SUPPLEMENTAL REBUTTAL FINDINGS OF FACT – SMITH CROSSINGS

The Central Point Planning Commission conducted a public Hearing for the Smith Crossings at Twin Creeks site plan application on June 6, 2017. At the request of a resident with standing, the public record was held open for 7 days to review the record and submit additional comments.

This document is the applicant's rebuttal to the written testimony submitted on or before close of business on June 13, 2017.

PLOT PLAN
PHASE 2 - 145 UNITS

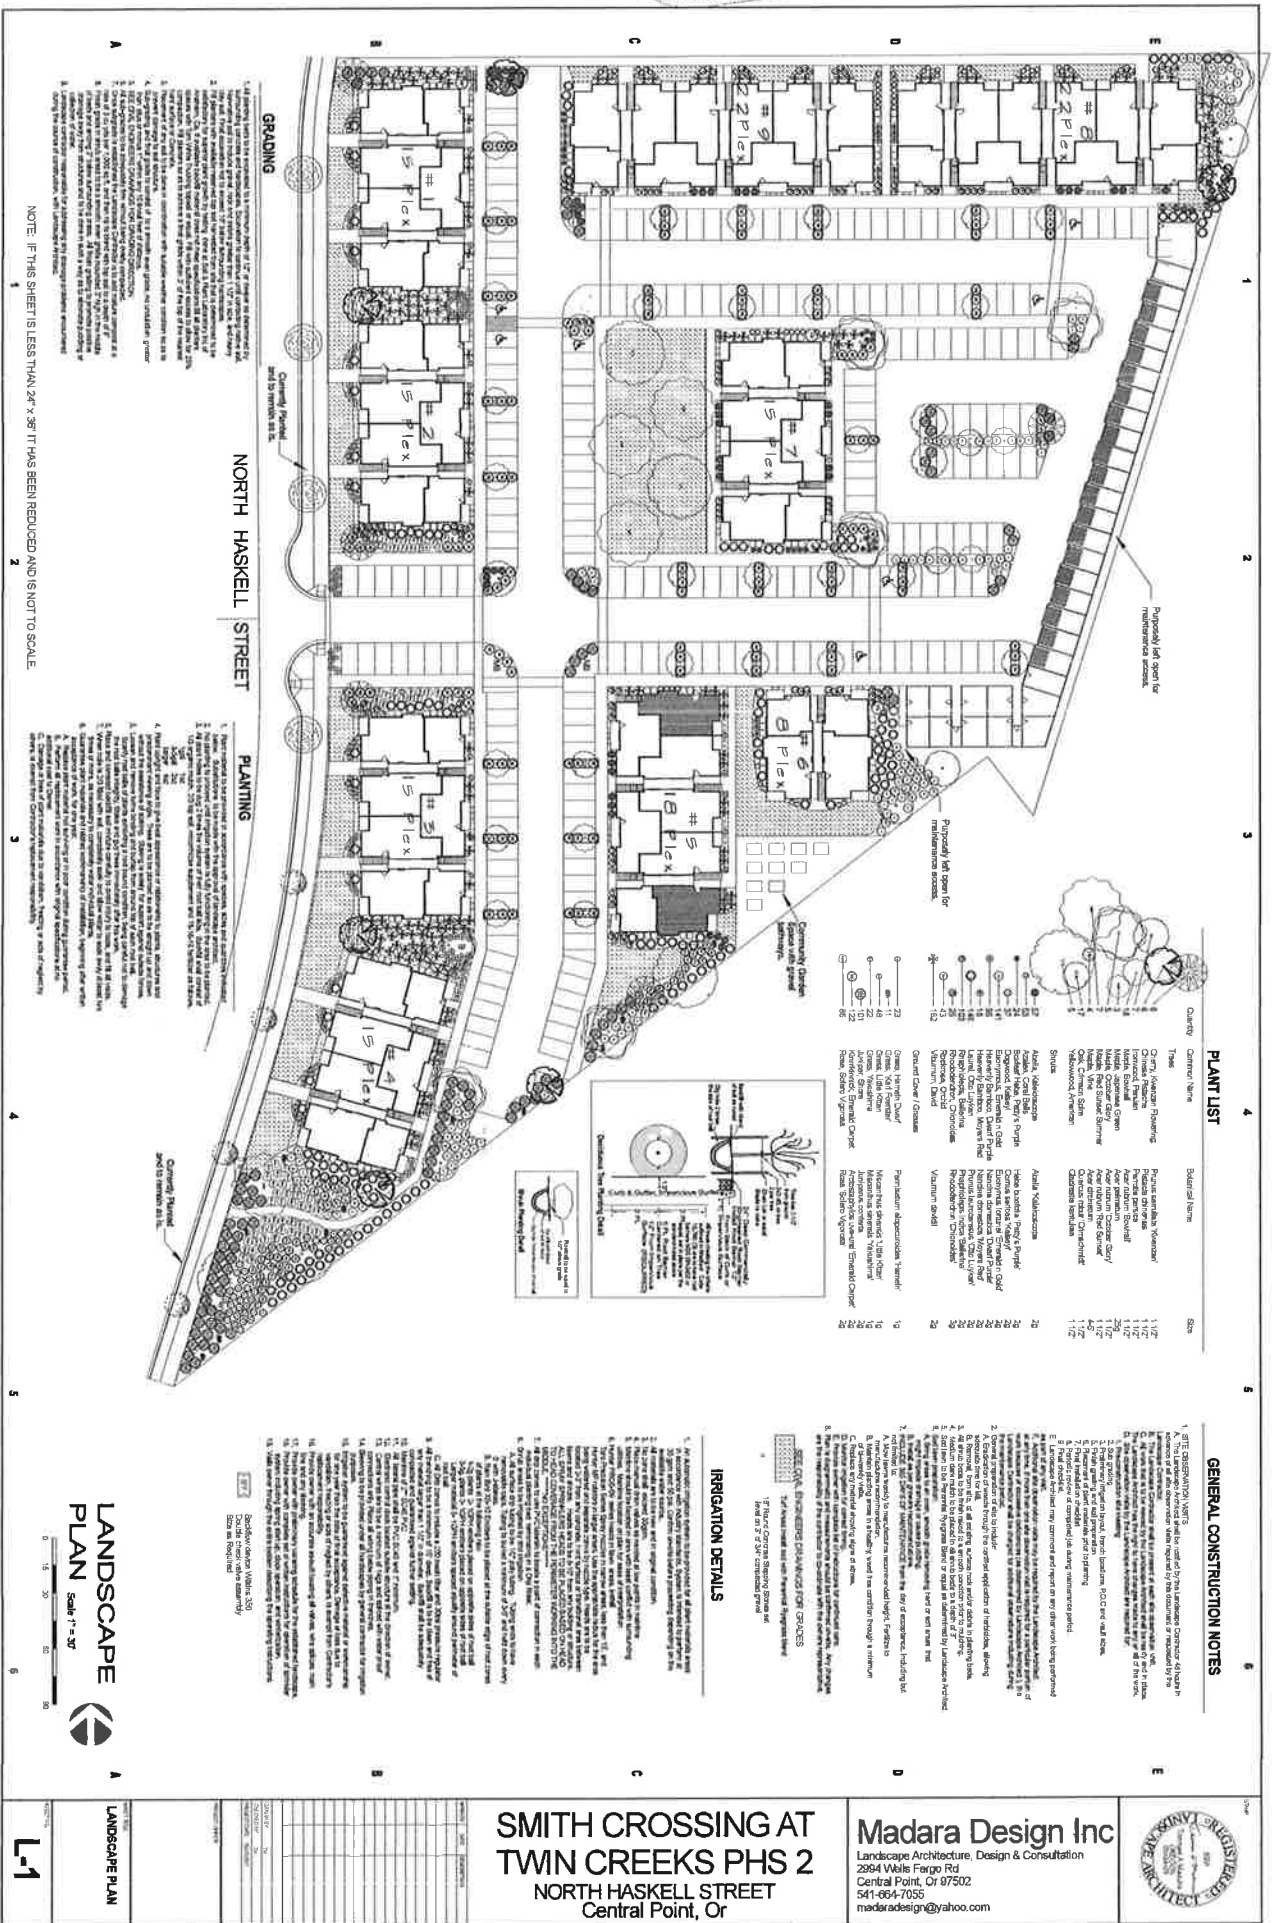
Testimony was presented at both the Public Hearing and the period of open record where citizens expressed concern for the on-street parking of the proposed development. The Central Point Municipal Code requires a minimum of 1.5 parking spaces per Dwelling Unit (DU) in the Twin Creeks Transit Oriented District (TC TOD). The code does not have a standard for the maximum parking in the TC TOD.

The site plan submitted with the application proposed 168 total parking spaces for the 100 DUs in Phase 1 for a 1.68 spaces per DU. Phase 2 proposed 145 DUs and 222 parking spaces or 1.53 spaces per DU. The Applicant responded the concerns expressed at the public hearing that proposed a revised site plan for Phase 2. The revised site plan proposes 30 additional spaces for phase 2 for a total of 252 spaces and 1.73 spaces per DU.

The site plan for Phase 2 was revised by reducing the amount of open space in the phase from the proposed slightly over 27% landscaped area to 22% landscaped area. The Code requires 20% landscaped area.

The applicant responded to the concerns raised in the testimony of the public hearing with a revised site plan for Phase 2 with an increase of 30 parking spaces while still meeting standards for landscaping.
